Project	IEEE 802.16 Broadband Wireless Access Working Group < http://ieee802.org/16 >	
Title	Addendum to Comment in Letter Ballot #13	
Date Submitted	2003-10-31	
Source(s)	Brian Eidson Conexant Systems, Inc. 9868 Scranton Rd, Suite 1000 San Diego, CA 92121 USA	Voice: (858) 713-4720 Fax: (858) 713-3555 mailto: brian.eidson@conexant.com
Re:	Letter ballot #13 on document IEEE P802.16-REVd/D1-2003	
Abstract	Letter ballot comment on revisions related to 8.3.1.4 too large and detailed for inclusion within Commentary.	
Purpose	To provide text and editing instructions for the comment referenced by author's Commentary submission.	
Notice	This document has been prepared to assist IEEE 802.16. It is offered as a basis for discussion and is not binding on the contributing individual(s) or organization(s). The material in this document is subject to change in form and content after further study. The contributor(s) reserve(s) the right to add, amend or withdraw material contained herein.

Addendum to Comment in Letter Ballot #13

Amendments related to WirelessMAN SC-a Burst Framing

Figure 194—Generating a Frame Segment from a Repeat Segment

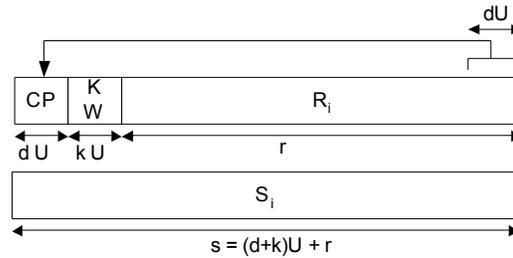
5. Form Frame Segments as shown in Figure 194, by prefixing each Repeat Segment with a Cyclic Prefix (CP) of length dU symbols and a Known Word. Each Cyclic Prefix of a Repeat Segment is composed of the last dU symbols in that Repeat Segment. d is a burst profile parameter.

Figure 195—Formation of subchannel frame from frame segments

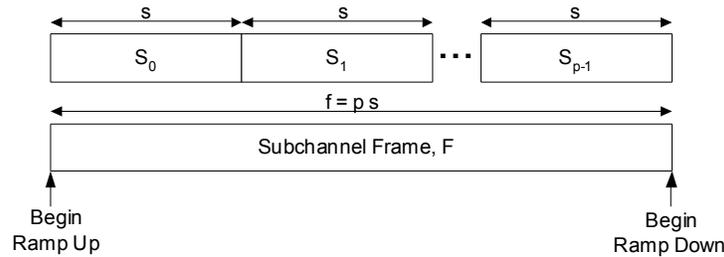
6. Concatenate Frame Segments to form a Subchannel Frame, as illustrated in Figure 195. Transmitter ramp up processing is applied to the first data in the burst; transmitter ramp down processing occurs directly following the last data in burst.

Figure 196—Frame segment alignment for overlapping bursts on different subchannels

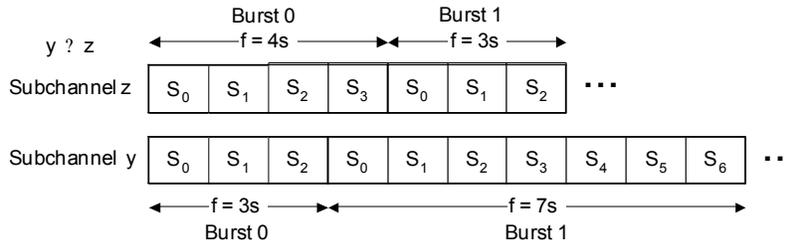
When transmissions on different subchannels overlap in time, their burst profile encodings for U , k , d , and r must all be common. Moreover, as illustrated in Figure 196, burst frame start times must be allocated such that constituent frame segments are time-aligned, although the start time and frame duration of independent bursts may be different.
